**Risks of reactor
Lifetime extension
Doel-4 and Tihange-3**

Opinion within the scope of the EIA procedure

Oda Becker, Gabriele Mraz (pulswerk GmbH)

Commissioned by Greenpeace Belgium

Figure 1: Major accident contamination at Doel-4 in Bq Cs-137 per m². Source: flexrisk.boku.ac.at.

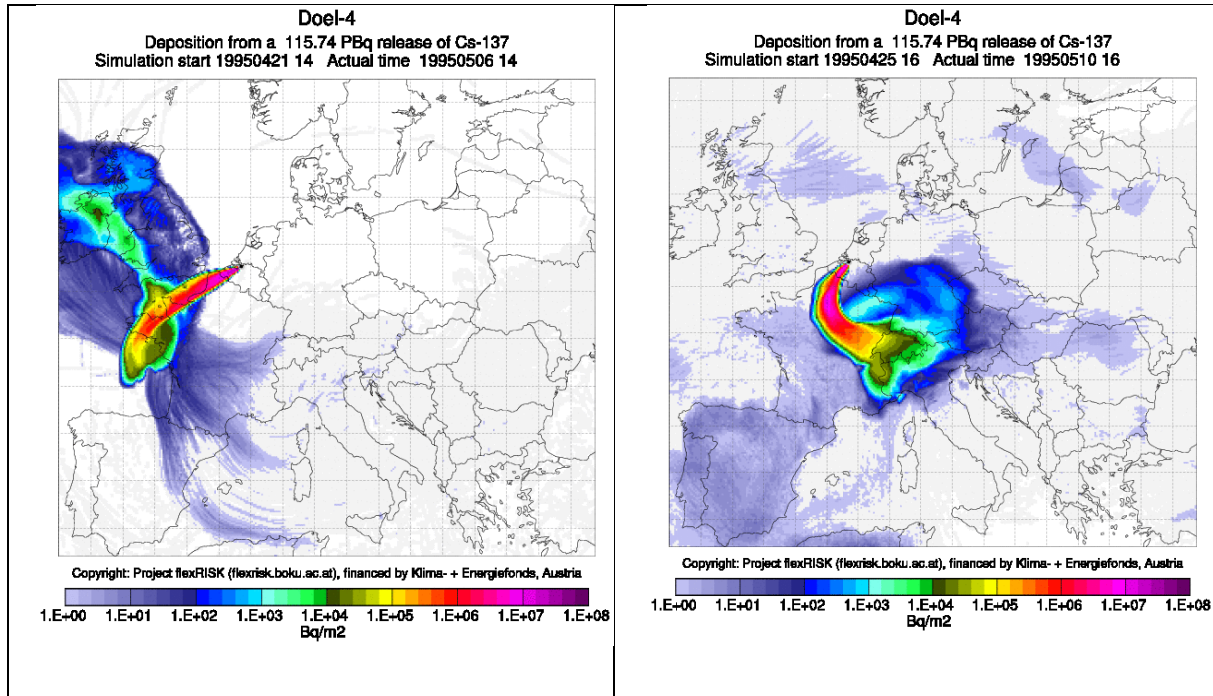
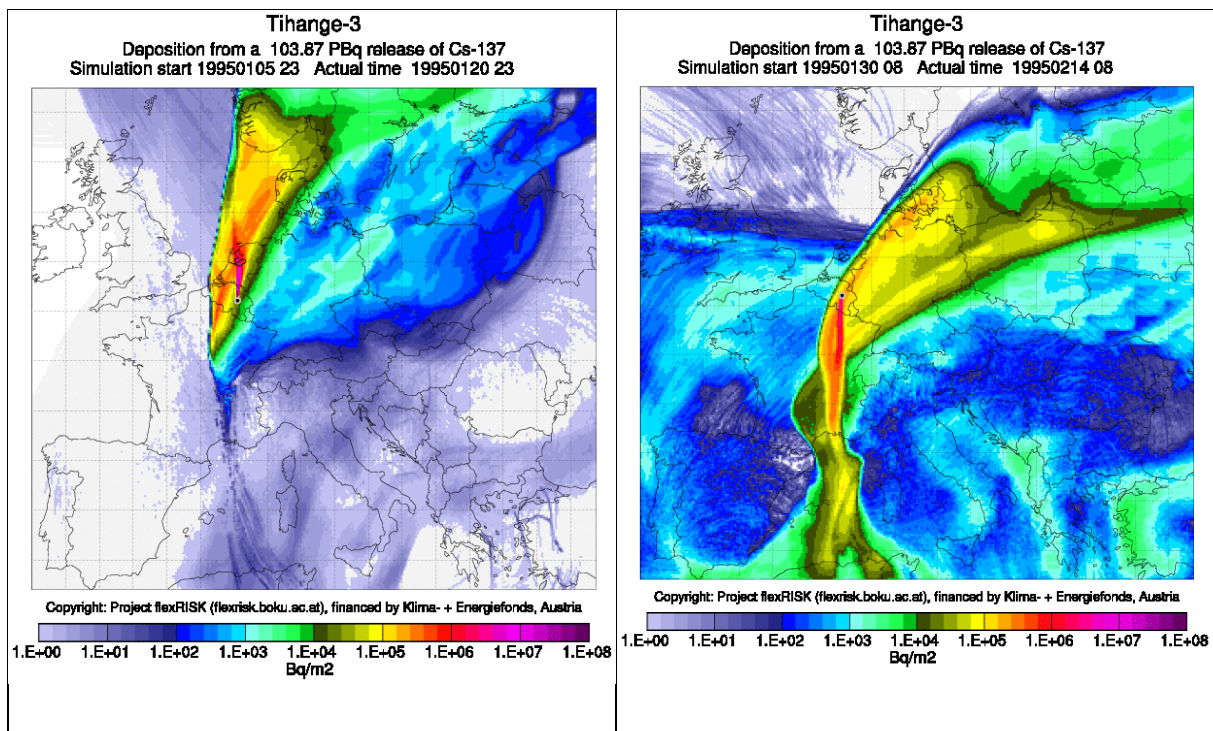
It is easy to see that the possible contamination from this assumed serious accident depends heavily on the weather. **Due to the weather conditions, large parts of Europe can be affected, as can be seen from the location and size of the orange, red and purple areas. For example, the radioactive cloud from a severe accident in Doel-4 would initially move to the south-east (via Luxembourg) under weather conditions like those of April 9, 1995, then move on via central and southern Germany, turn off via the Czech Republic, Austria and Switzerland and move on to Italy .**

However, it must be taken into account that these calculated accidents are by no means the worst possible accidents. **In the flexRISK project, a possible accident with containment failure was calculated for both reactors. These results show that large parts of Europe could become contaminated . Areas northeast of the relevant nuclear power plants have the highest weather-related probability of being contaminated by a severe accident. Such an accident could even result in areas in and around Belgium having to be resettled .**

The transboundary impacts for a major accident should be calculated in the EIA process, regardless of the estimated probability of occurrence, as long as it is physically possible in order to clarify the risk. The results of the flexRisk project determined the massive impact of such an accident for Belgium and Europe.

Figure 3: Weather-related probability of being contaminated by a severe accident in Doel-4 and Tihange-3 with more than 37 and 1,480 kBq Cs-137/m². Source: flexrisk.boku.ac.at.

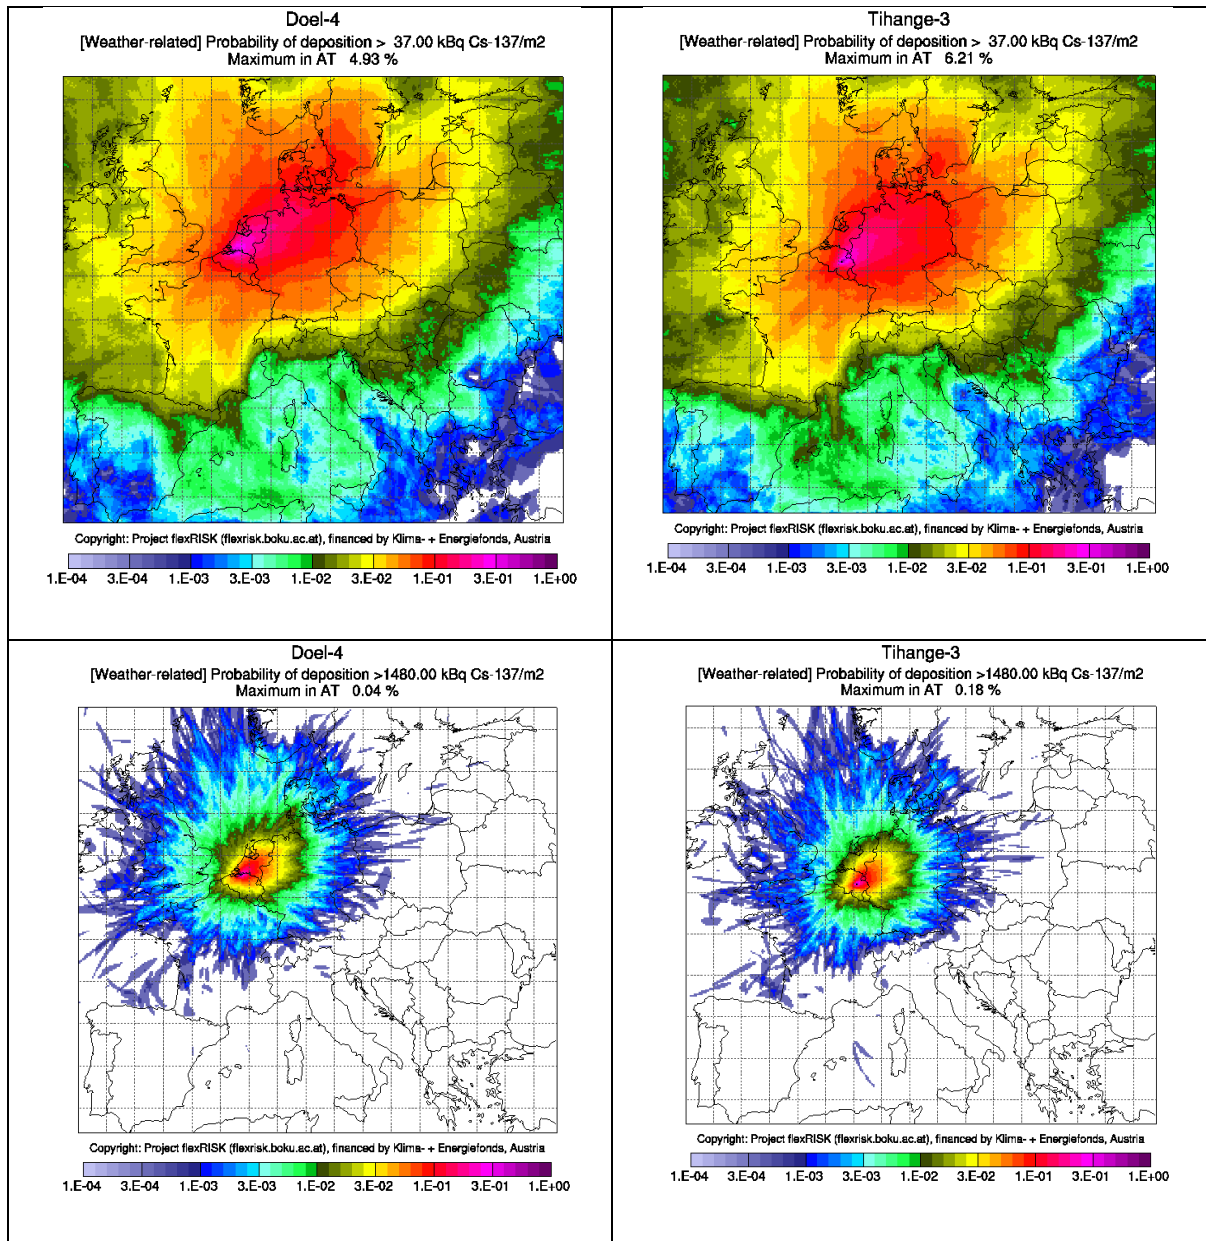
Areas northeast of the relevant nuclear power plants have the highest weather-related probability of being contaminated by a severe accident, this is the most common wind direction. **The two lower figures (probability of contamination with 1,480 kBq Cs-137/m²) show which areas have a high probability of having to be evacuated in the event of the assumed serious accident; these are by no means only areas in Belgium, but also in the neighboring countries, with a higher probability in the north-east direction.**
